East Fairhaven Elementary School

Town of Fairhaven ADA Transition Plan

October 2024

Institute for Human Centered Design

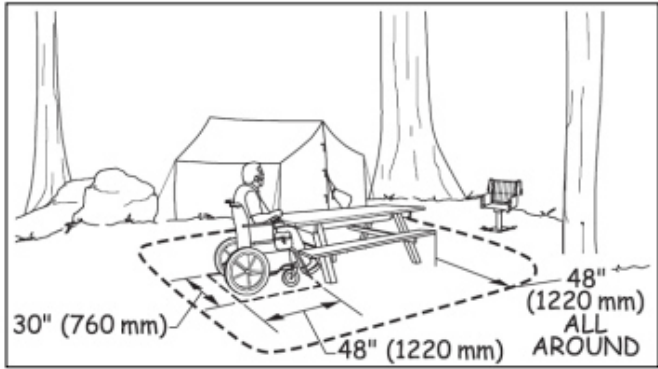
- Recommend providing a height adjustable exam table in the nurse’s office.
- Recommend repainting the crosswalk between the passenger loading zone and the path to the basketball court.
- Recommend providing a clear floor space alongside one bench in each area where benches are provided that does not exceed a slope of 2.00% surface at least one bench, positioned to allow a person in a wheeled mobility device and a person sitting on the bench to have their shoulders aligned. See the following diagram:

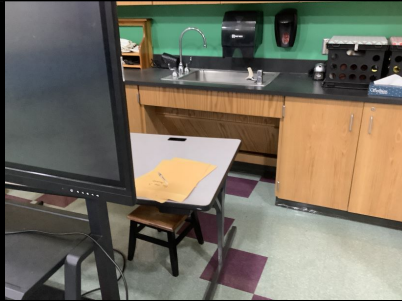
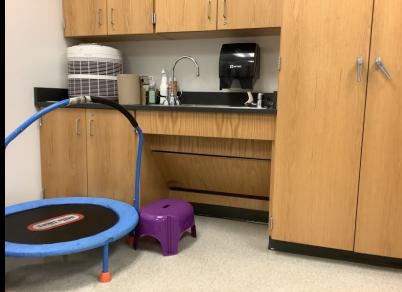
140	
Dispensers												
77	Nurse's Office Single-User Toilet Room	1	-	Dispensers	Soap Dispenser		Dispenser acts as a protruding object	7"	Relocate the soap dispenser out of the circulation path.	1	500	\$500
											500
